***Technical Committee on
Private Water Supply Piping Systems***

SUBJECT: **AUT-PRI AGENDA PACKAGE – A2012 ROP Meeting**

REPORT ON PROPOSALS (ROP) MEETING
NFPA Technical Committee on
Private Water Supply Piping Systems

**PART 7 – ANNUAL 2012 PUBLIC PROPOSALS
AUT-PRI**

FIGURE A.10.6.3.1 Riser Entrance Location.

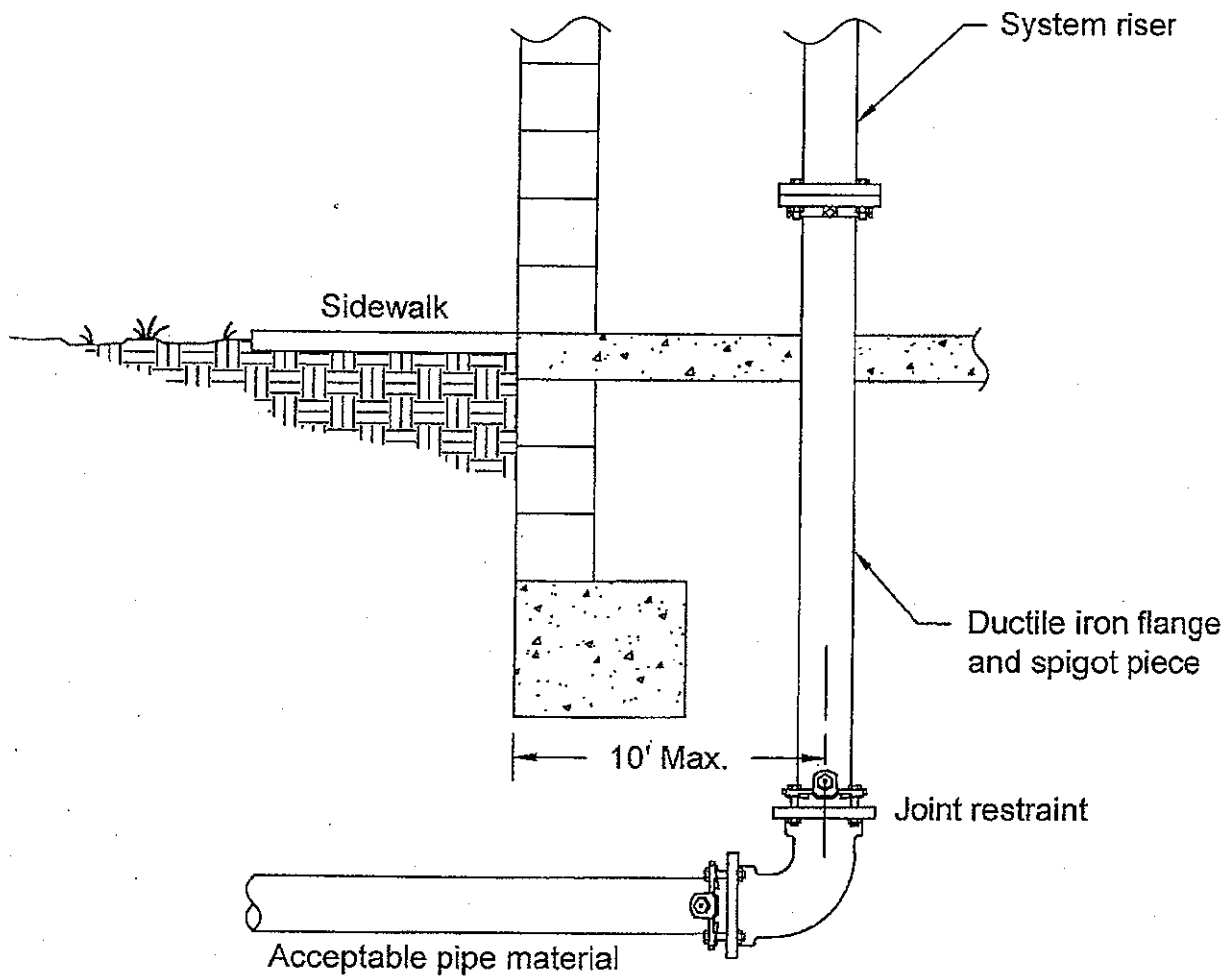
A.10.6.3.1 The 10'-0" should be measured from the edge of the building or foundation to the center of the vertical pipe. Items such as sidewalks or patios should not be included as they are no different than roadways. See Figure A.10.6.3.1

FIGURE A.10.6.6 Piping Clearance From Foundation.

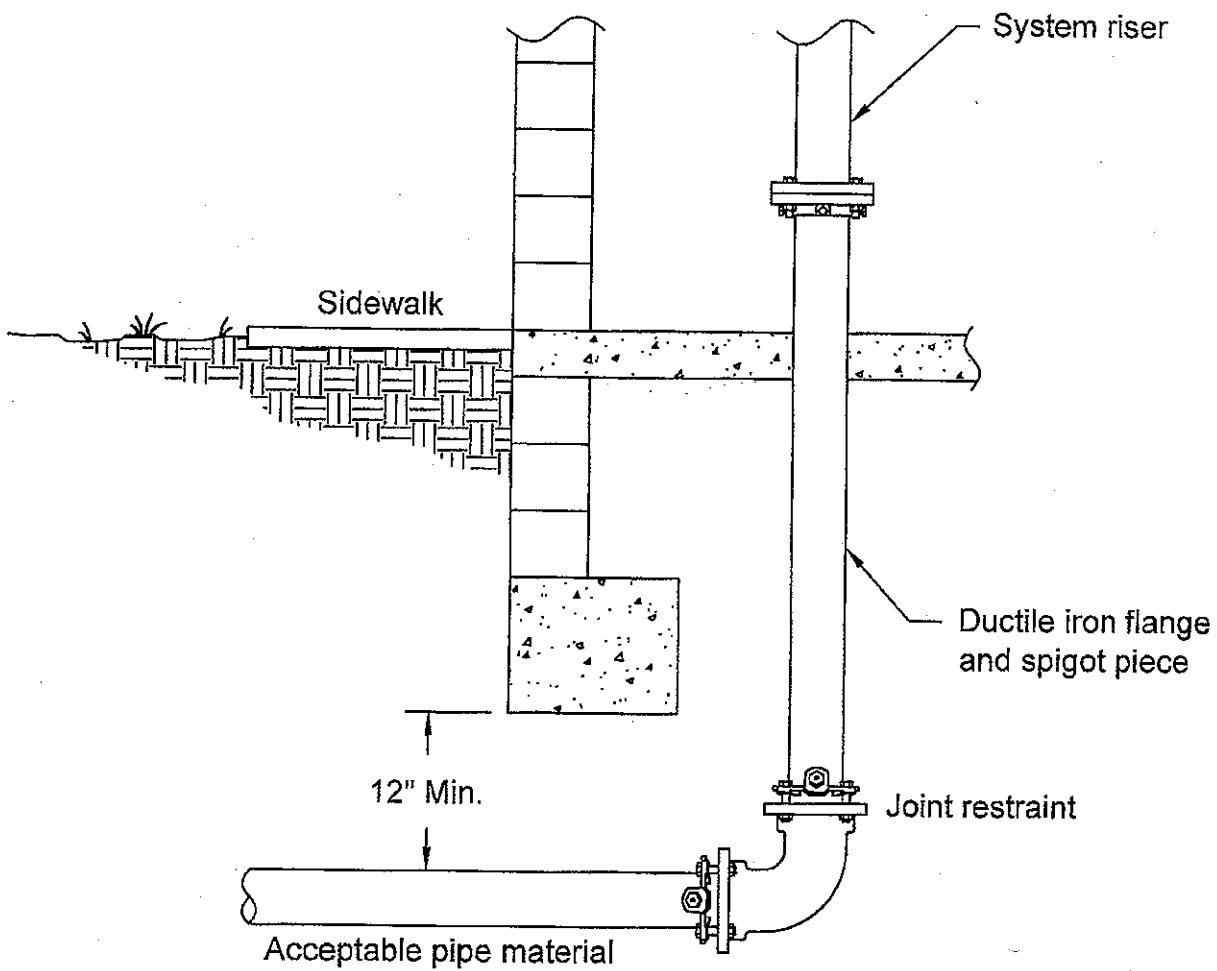
A.10.6.6 Sufficient clearance should be provided when piping passes beneath foundations or footers. See Figure A.10.6.6

Substantiation: Currently there is no specific requirement as to how far under the footer the piping should be. 12" is a reasonable distance to account for settling of the building.
